INITIAL FIRE SAFETY INSPECTION REPORT

Factory Name: ECHOTEX LTD. (Extension 2)

RSC ID: 24587

Date: 11 March 2024

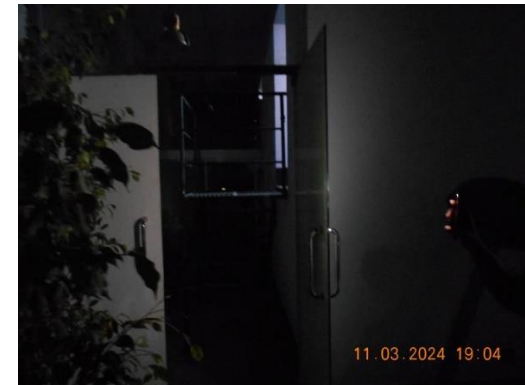
F-20	Fire Rated Construction	Office Building The exit stairs are not separated from work areas, other spaces on each floor by fire-rated construction.	Provide minimum 2-hr fire rated construction for buildings 4 storied or more and 1-hr for upto 3 storied. Seal all unprotected openings to separate the exit stairs from work areas and other spaces on all floor levels by 90 minutes for 2 hr construction and 60 minutes for 1-hr construction. Ensure that the fire rated doors are self-closing and positive latching and that they are provided with fire exit (panic) hardware where serving production floors and provide vestibules to avoid direct discharge from storage to exit stair enclosure. If fire rated doors are required to be held open for functional reasons, provide automatic closing devices tied to the fire alarm system. Once fire doors are installed, every door in a stair enclosure serving more than 5 stories shall be provided with re-entry unless it meets The RSC Technical Guidelines (Standard) 6.8.3.1	Within 3 months

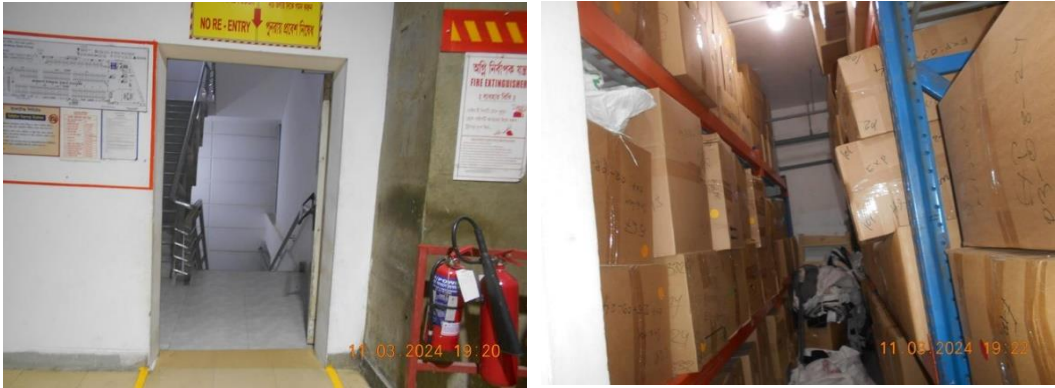
F-22	Fire Rated Construction	Office Building Unsealed penetrations and openings are located in the fire rated floor/ceiling assemblies. Followings are the description of openings or penetrations indicating specific locations: 1. Passing of IT/Network cable riser through floor slabs from ground floor to top floor of the building. 2. Plastic pipes penetrate the floor slabs in toilet block of the building. 3. Electrical cable riser through rated walls on several floors of the building.	Seal all penetrations and openings in floor/ceiling assemblies to maintain the fire separation at least by 3-hr. The used sealer shall be 3rd party certified and installation shall be as per manufacturer's datasheet. Or Provide a minimum 2-hr fire rated shaft to separate the utility risers from each floor if required. If fire doors are required to be held open for functional reasons, provide automatic closing devices tied to the fire alarm system.	Within 3 months
